Intersection ID: 47122	Main Street: THOMPSON_BROOK_LN	Cross Street: DION_AV	Location:	E
ADA ID: F920C06D3749	Ramp Type: PerpDiag	Initial Pass/Fail: Fail	Overall Compliance: No	Severity Score: 13.75

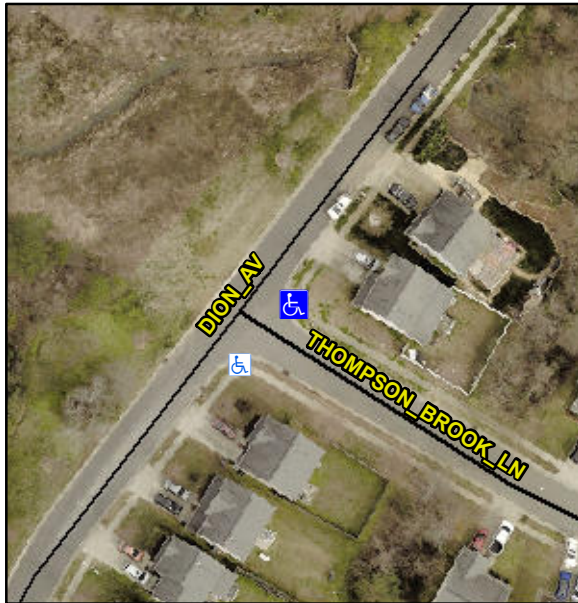
**Not Found, R304.2.2, R304.5.3**

Compliance	Description	Data	Compliance	Description	Data
N/A	Ramp Length (in)	44.5	No	Ramp Slope (%)	8.6
Yes	Ramp Width (in)	48.0	No	Ramp XSlope (%)	3.9
N/A	Flare Type LT	N/A	N/A	Flare Type RT	N/A
N/A	Flare Slope LT (%)	N/A	N/A	Flare Slope RT (%)	N/A
N/A	Flare Traversable LT?	N/A	N/A	Flare Traversable RT?	N/A
N/A	Landing Length (in)	N/A	N/A	DWS Provided?	N/A
N/A	Landing Width (in)	N/A	N/A	DWS Contrast?	N/A
N/A	Landing Slope (%)	N/A	N/A	DWS Length (in)	N/A
N/A	Landing X Slope (%)	N/A	N/A	DWS Full Width?	N/A
N/A	Landing Curb? (Y/N)	N/A	N/A	DWS Offset (in)	N/A
N/A	Shared Landing?	N/A			
N/A	Gutter Ponding?	N/A	N/A	Gutter Slope (%)	N/A
N/A	Gutter Lip Ht (in)	N/A	N/A	Gutter X Slope (%)	N/A
N/A	Painted X Walk1?	No	N/A	Painted X Walk2?	No
	X Walk 1 Direction	To NW		X Walk 2 Direction	To SW
N/A	X Walk 1 Width (in)	N/A	N/A	X Walk 2 Width (in)	N/A
	X Walk 1 Slope (%)	0.1		X Walk 2 Slope (%)	3.8
	X Walk 1 X Slope (%)	4.8		X Walk 2 X Slope (%)	1.2

**Remove & Replace Curb Ramp With Two New Directional Ramps or Equivalent.**
